TECHNICAL REVIEW AND EVALUATION
OF THERMAL EFFECTS STUDIES AND
COOLING WATER INTAKE STRUCTURE
DEMONSTRATION OF IMPACT FOR THE
OYSTER CREEK NUCLEAR
GENERATING STATION

REVISED FINAL REPORT

New Jersey Department of
Environmental Protection
Division of Water Resources
401 E. State Street
Trenton, NJ 08625

Versar, Inc.
ESM Operations
9200 Rumsey Road
Columbia, MD 21045

Figure IV-2. Forked River mouth surface temperature and associated environmental data June 24-July 16, 1974 (from JCP&L 1978)

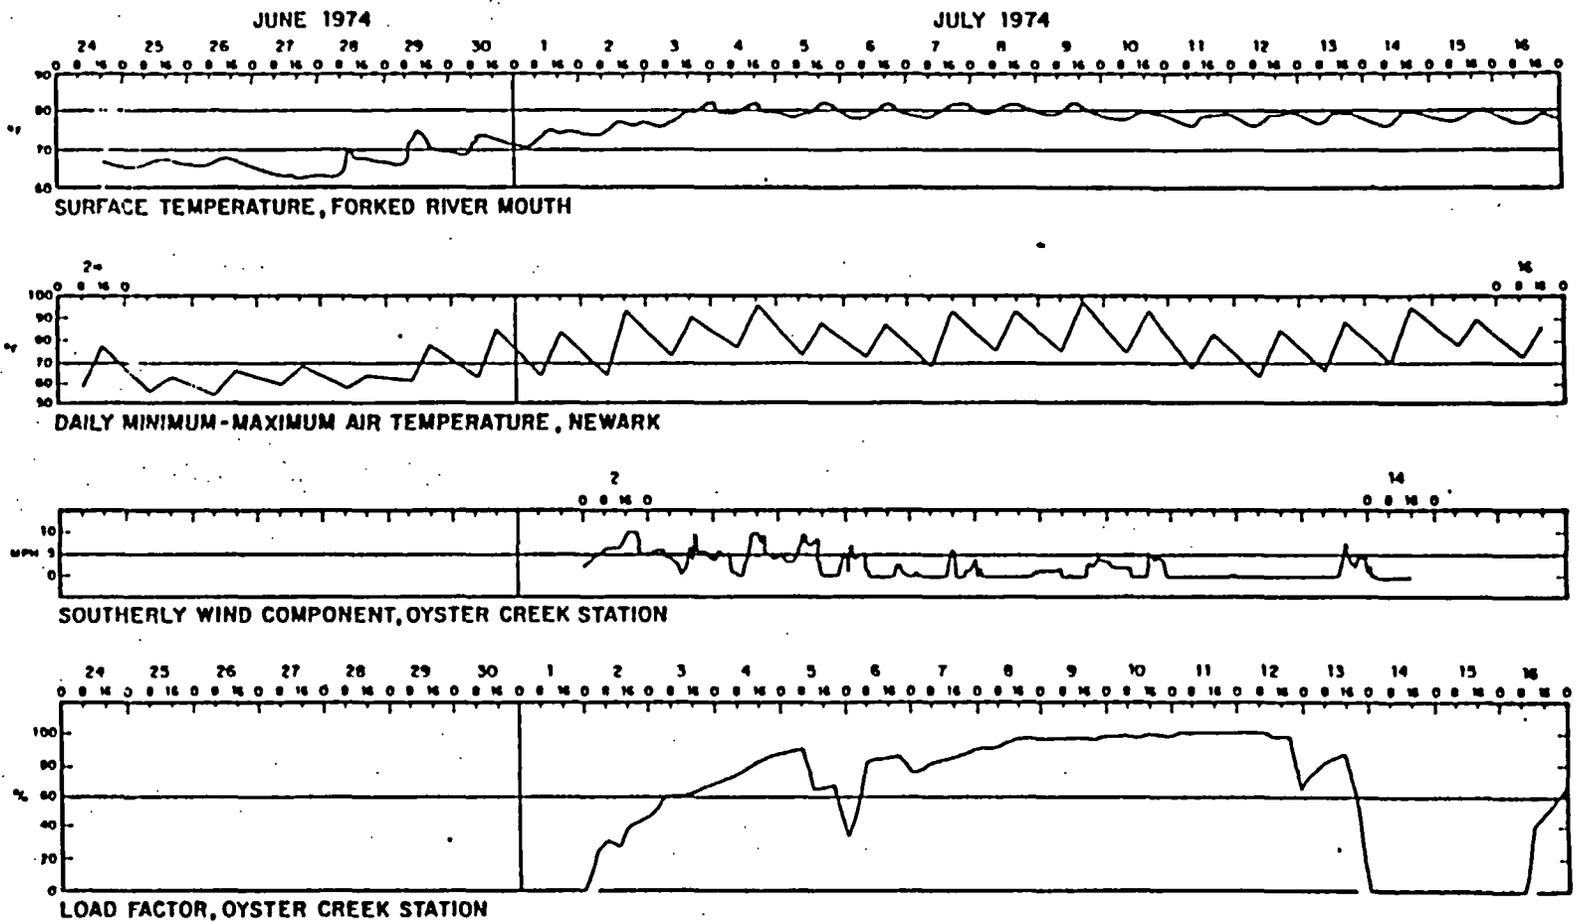
GPUN used a hydrothermal model to assess the compliance of the Oyster Creek's discharge with the thermal regulations. The model was formulated as a two-dimensional steady-state mass and heat balance, and was calibrated to dye and thermal survey data. Early attempts at verification indicated that results predicted by the steady-state model for segments upstream (north) of Oyster Creek were significantly different from observed dye results (Carpenter 1963). No reasonable set of parameters would produce steady-state model agreement with the survey results. Modification of the model to a one-dimensional unsteady-state, constant parameter model produced "adequate" verification. Versar contends that the "adequate" verification is minimal and simply confirms that the steady-state model is a poor reflection of the dynamic conditions characterizing Barnegat Bay. The model was tested under assumed wind/tide conditions. Limited information on model inputs or parameters was presented, and the information provided in the 316 Demonstration documents was inadequate to evaluate the model calibration or validation procedures.
